Cordillera Valley Club

Design Review Board

Cordillera Valley Club Design Review Board *Staff Memorandum*

Owner: David Bloch
Address: 94 Juniper Lane
Legal Address: F1 L18
Architect: Adam Harrison, Shephard Resources Inc.
Staff Contact: Allison Kent, AICP
DRB Hearing #1: January 22, 2025

② LOWER LEVEL PROPOSED PLAN
1/4" = 1'-0"

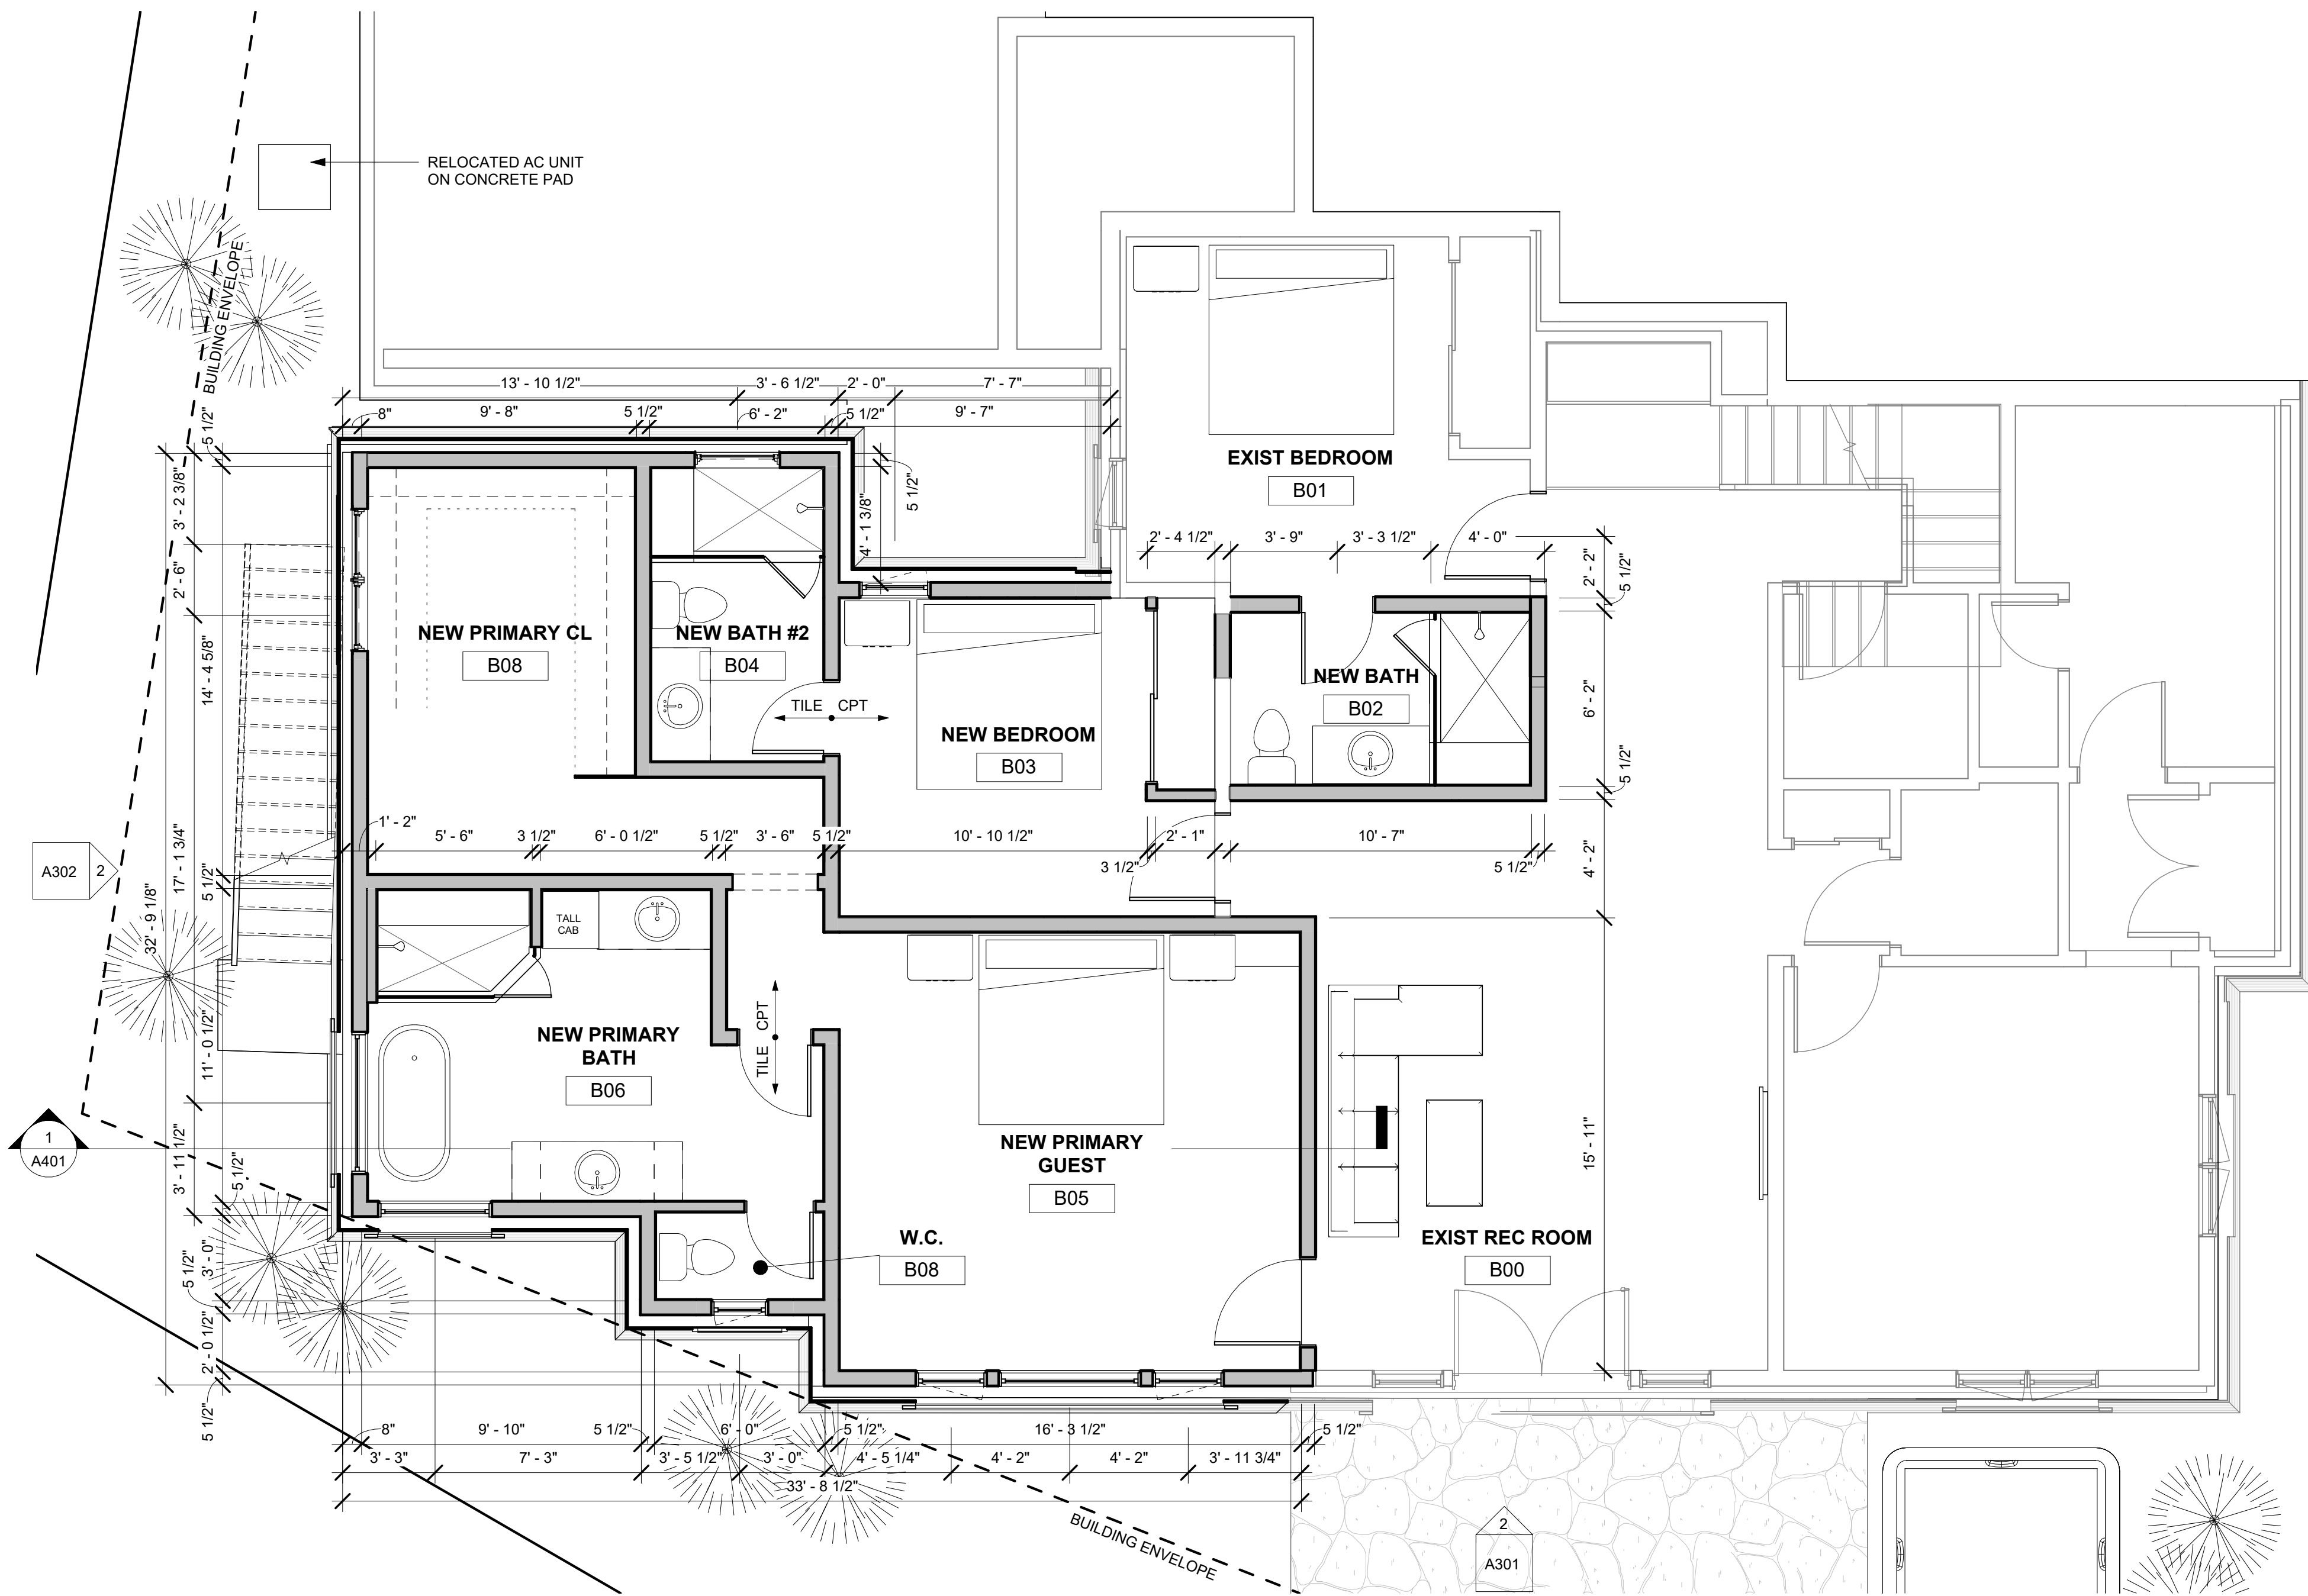
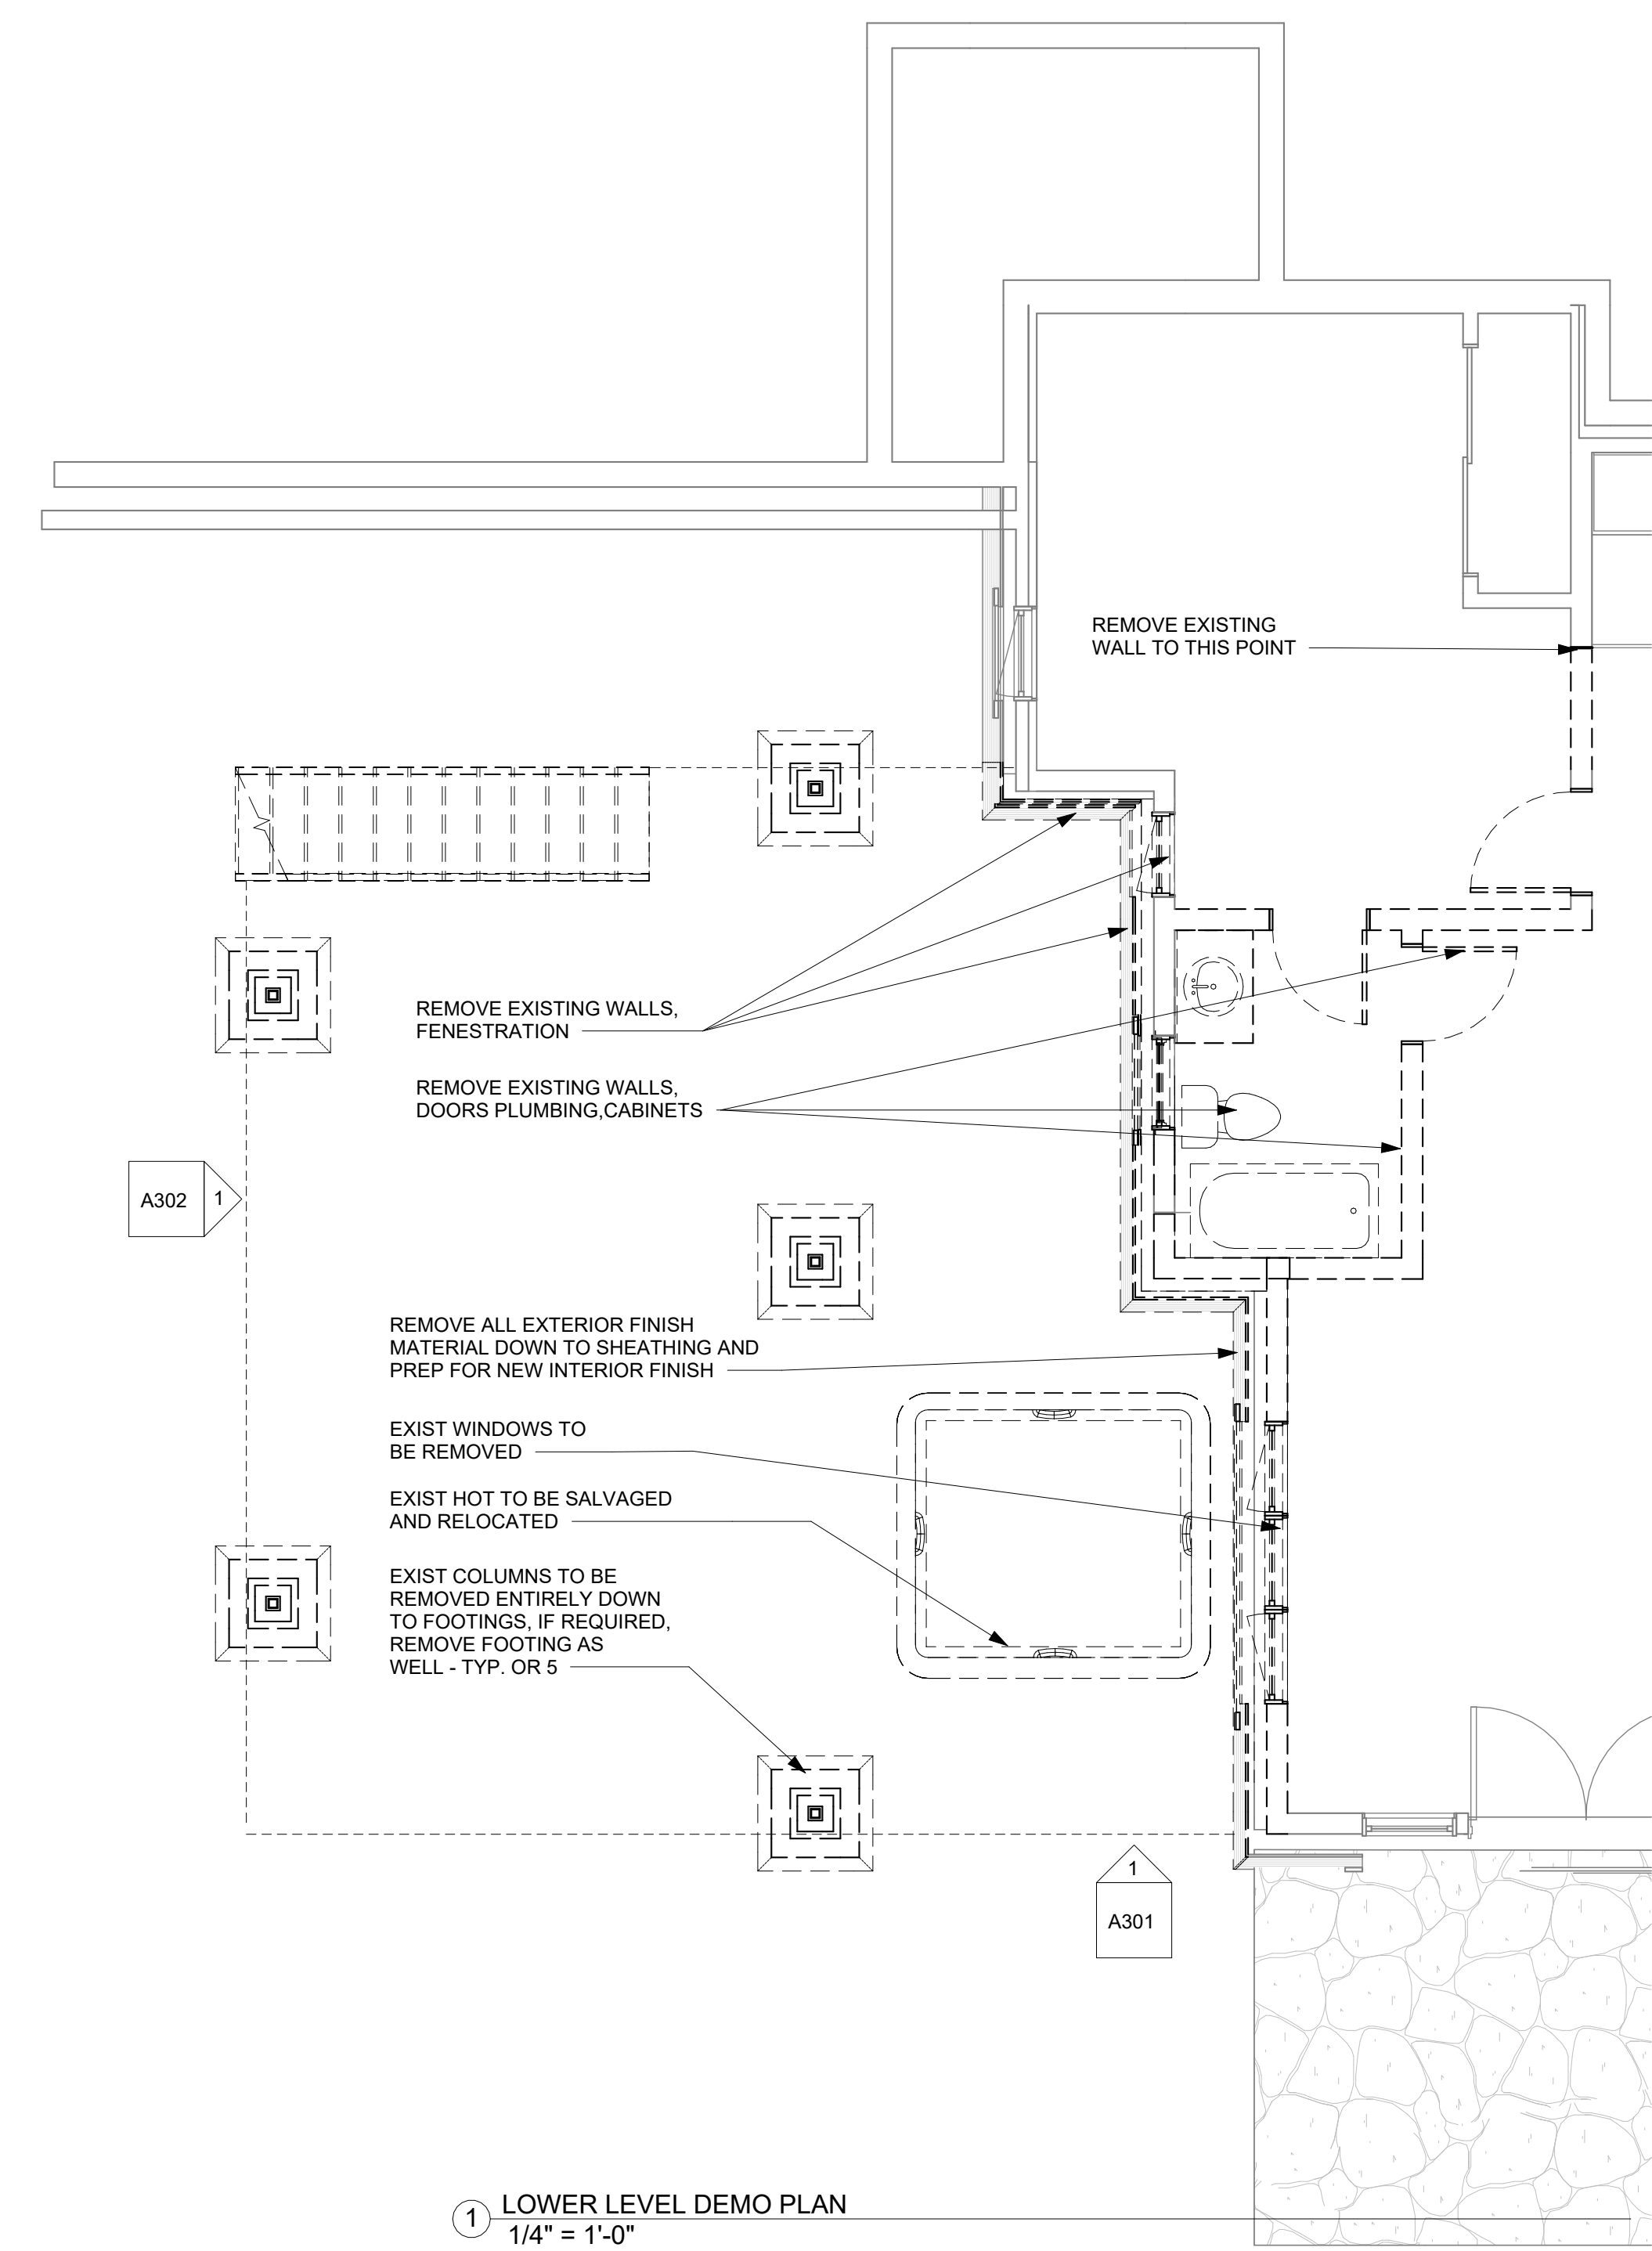
1. Sheet A201 shows the Lower Level Proposed Plan. The plan shows portions of the exterior building walls located outside the building envelope, which is not consistent with Sheet A202. Exterior walls must be within the building envelope. This plan must be revised. Due to the proximity of improvements to the building envelope and the property, an ILC will be required to demonstrate compliance.

1 DECK RAILING DETAIL
1 1/2" = 1'-0"

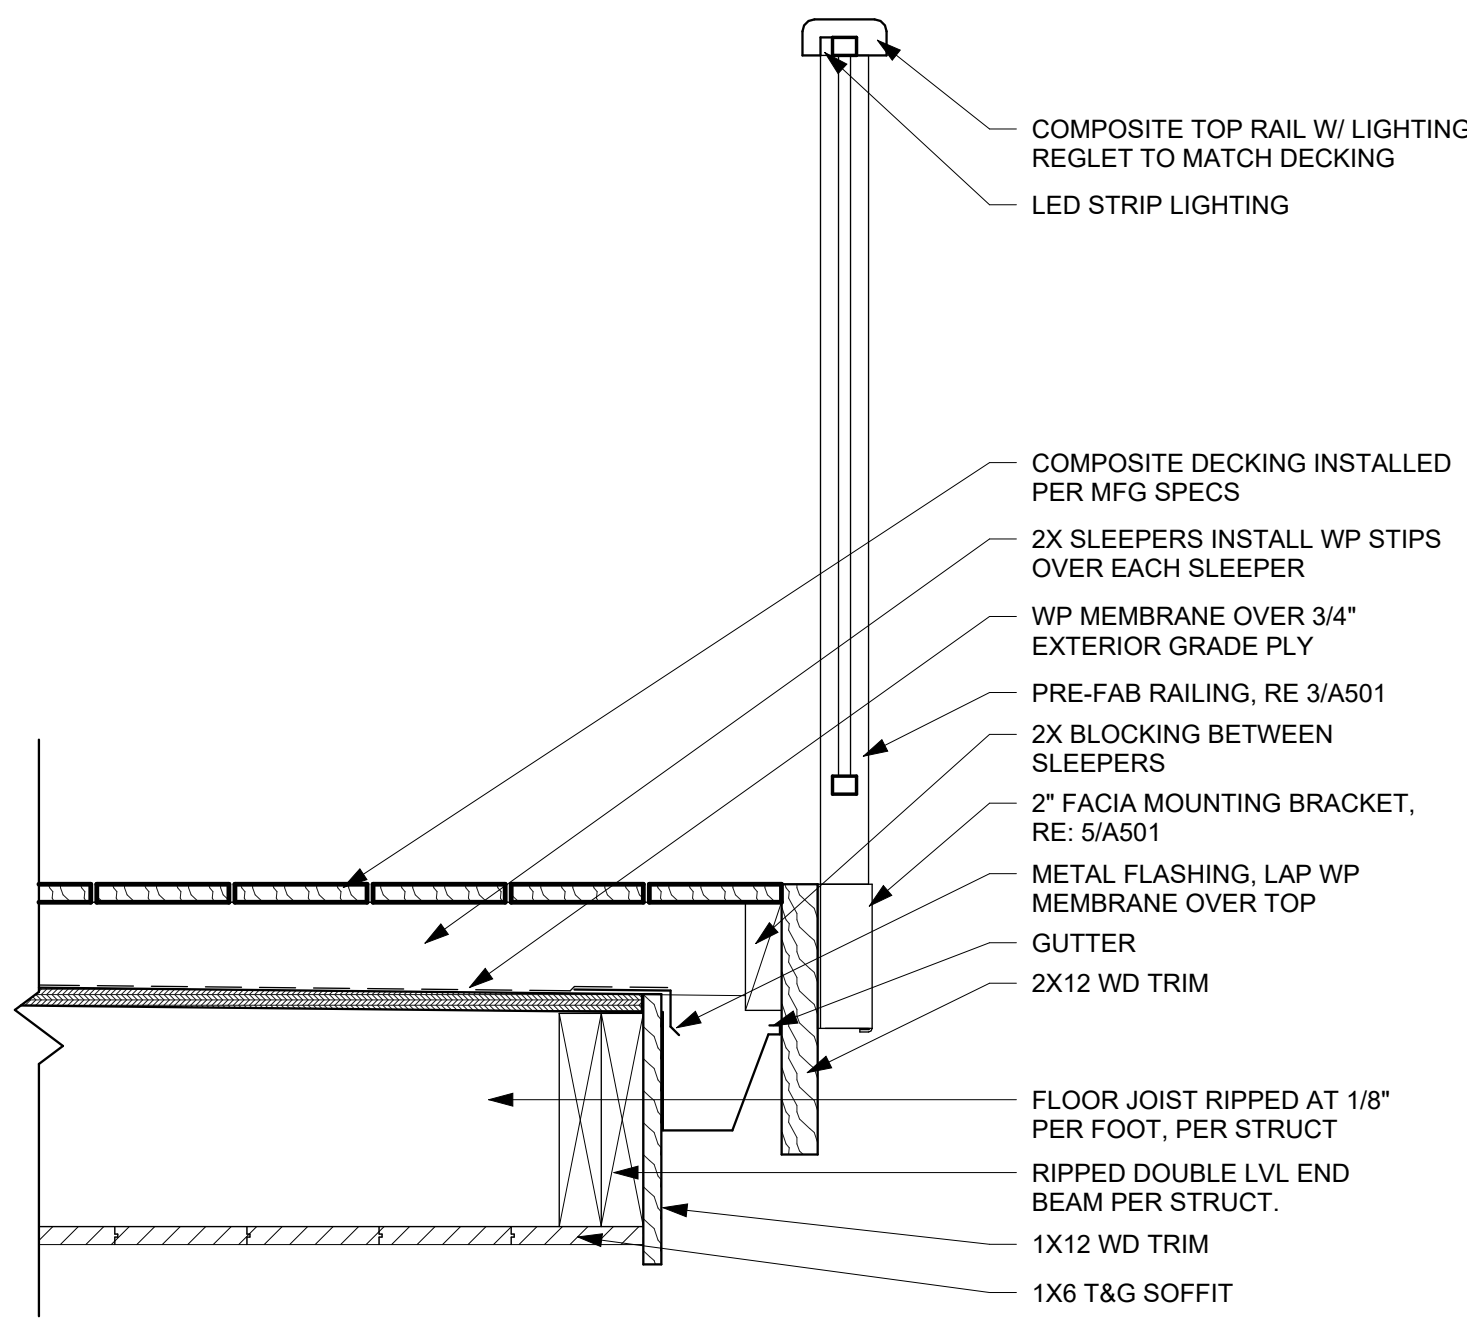
2. The applicant has shown LED lighting in the decks. This is not permitted and must be removed from the plans. Any proposed additional lighting shall be shown on a separate lighting plan, with proposed fixtures and demonstrated compliance with dark sky requirements. Exterior lighting cannot be shown on a deck rail detail.

4. Prior to Technical Review, the applicant must remove the lighting on the deck rail detail. Any proposed exterior lighting must be shown on an exterior lighting plan, demonstrate compliance with the Design Guidelines, and be submitted to staff for review.
